REMARKS

The Office Action of July 26, 2005, and the cited art have been carefully considered. The application has been amended to eliminate unnecessary limitations and to correct grammatical and similar errors. Reconsideration of the rejection of the application is respectfully requested based on the amendments and following discussion.

FIG. 1

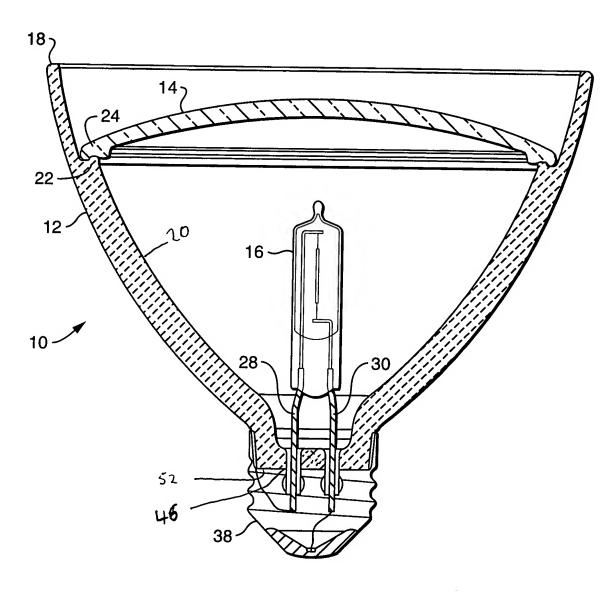
In particular in Claim 1, "first edge" was identified.

In claim 13 "end wall" was identified.

The drawings were objected to under 37 CFR 1.84(p)(5) for not including reference sign "interior wall 20"

FIG. 1 shows a first edge identified as item 46.

FIG. 1 shows an end wall identified as item 52.

FIG. 1 shows an interior wall identified as item 20.

FIG. 2

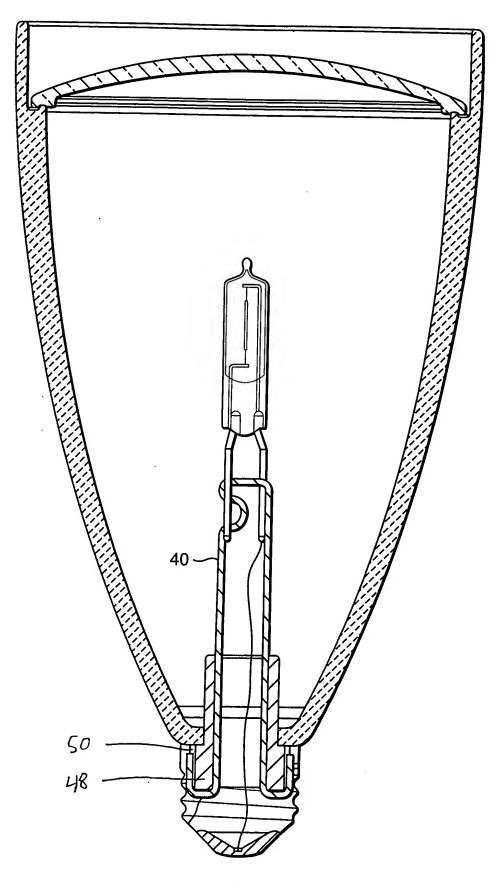
In claim 6, "rigid non-conducting body" was identified.

In claim 6 "axially-extending crevice" was identified.

FIG. 2 shows a rigid non-conducting body identified as item 48.

FIG. 2 shows an axially-extending crevice identified as item 50.
